SUBJECT: DOE-NRC TECHNICAL MEETING SUMMARY

Enclosed is a summary of the DOE-NRC meeting held in San Francisco, California on October 16-18, 1984 at the office of Woodward-Clyde Consultants. The meeting was a review of geophysical data for the Paradox Basin.

NRC DATA REVIEW OF GEOPHYSICAL DATA FOR THE PARADOX BASIN  
16 to 18 October, 1984  
Woodward-Clyde Consultant office  
San Francisco, CA

## GEOLOGY-GEOPHYSICAL DATA REVIEW CHECKLIST

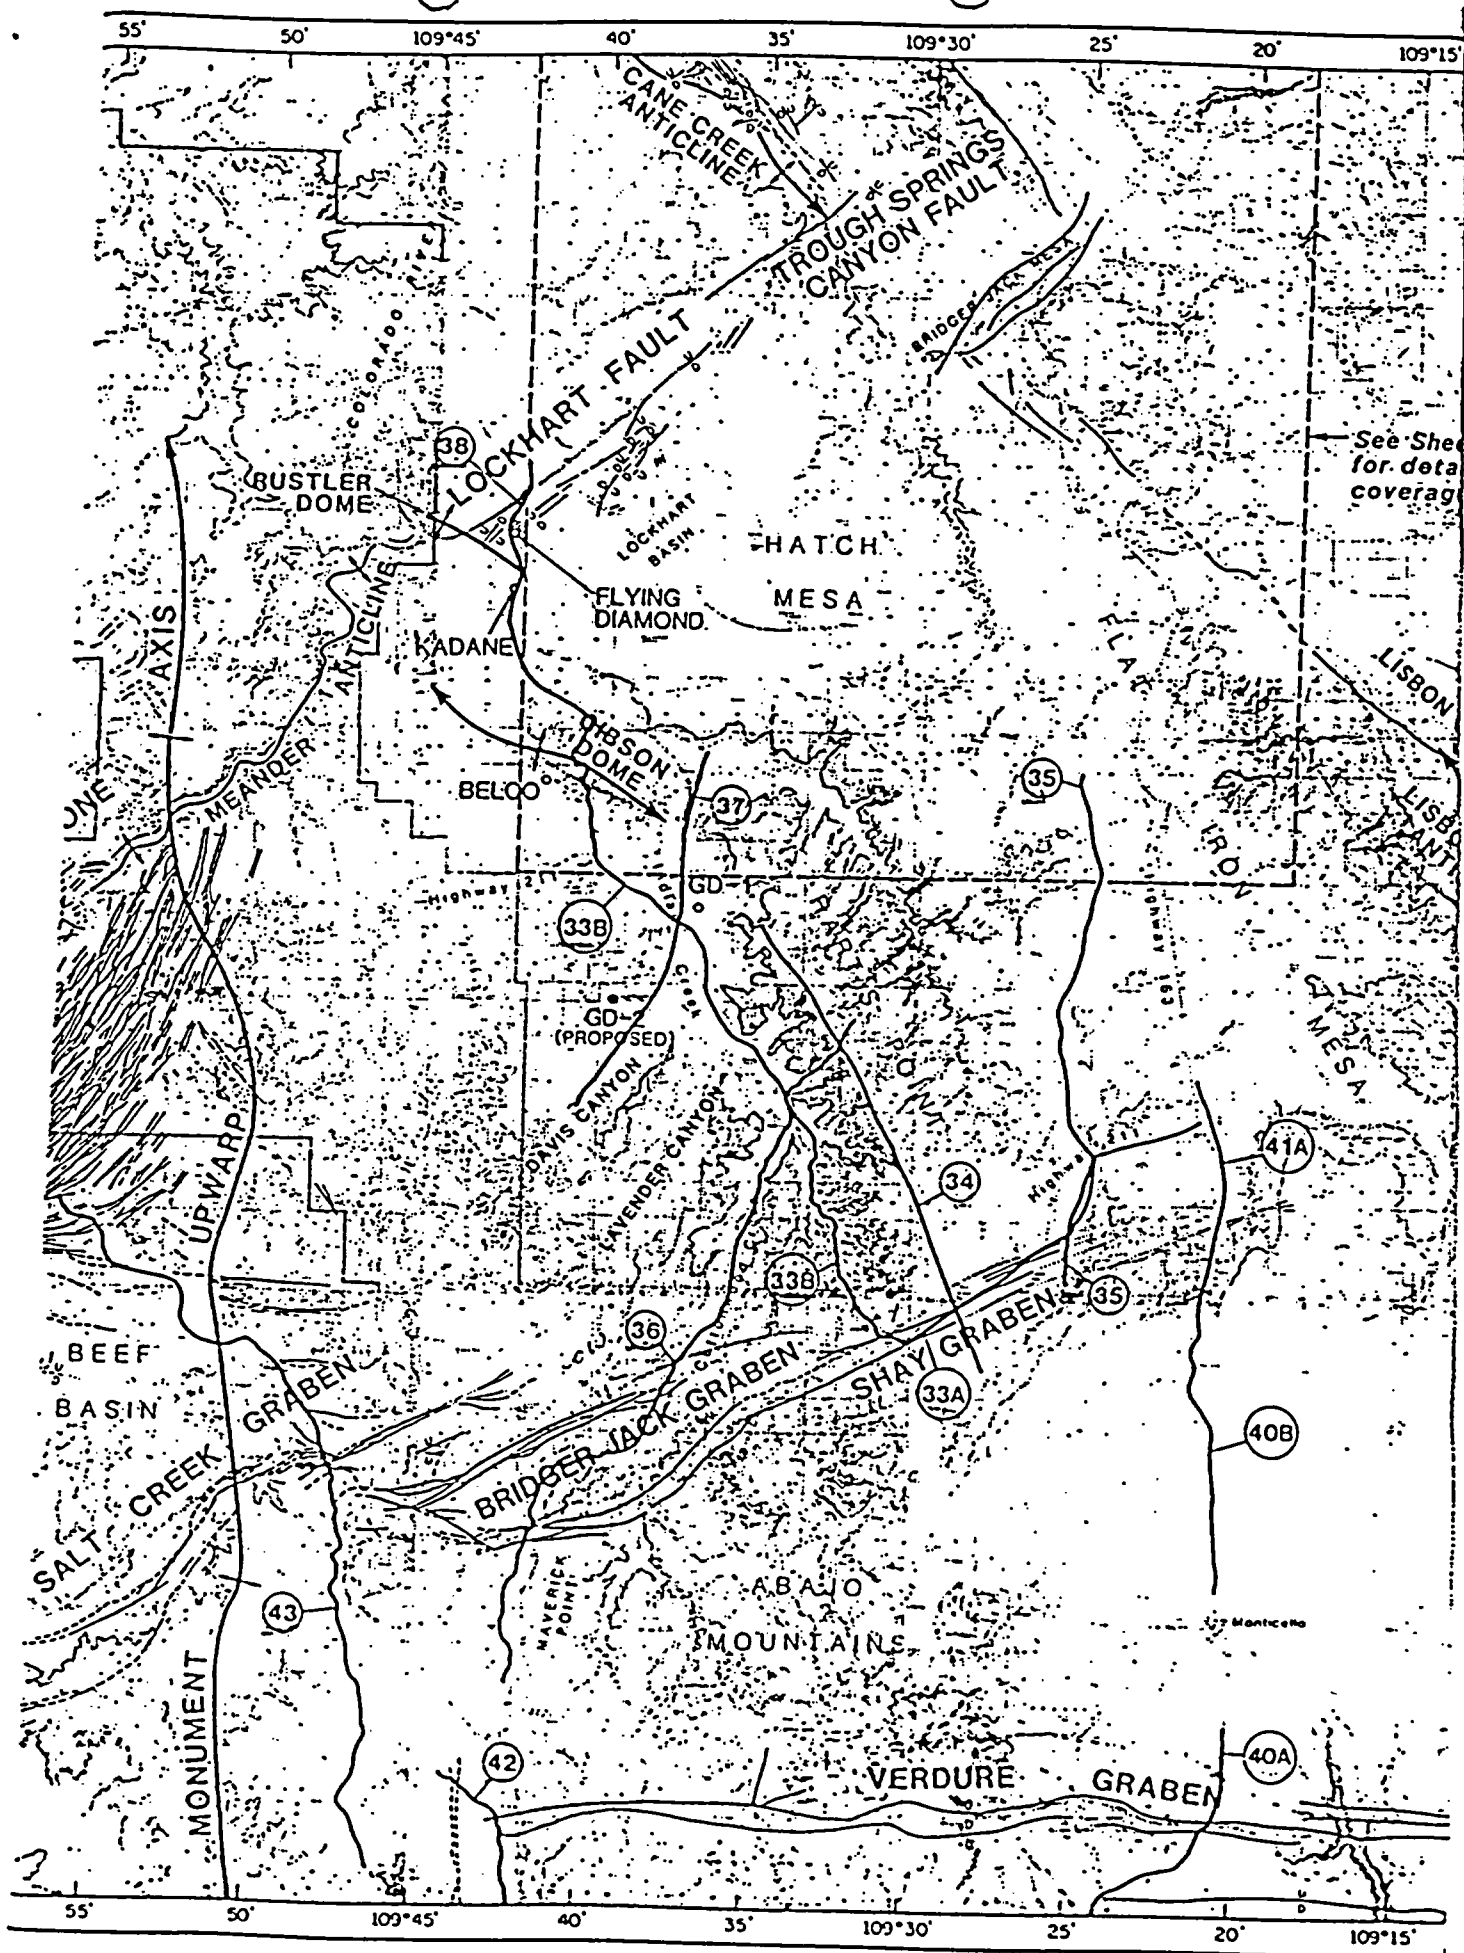
NORMAL DATA PROCESSING USED. SEE ATTACHED HEADER SHEET  
EXAMPLE FROM LINE 37 DAVIS CANYON AREA.
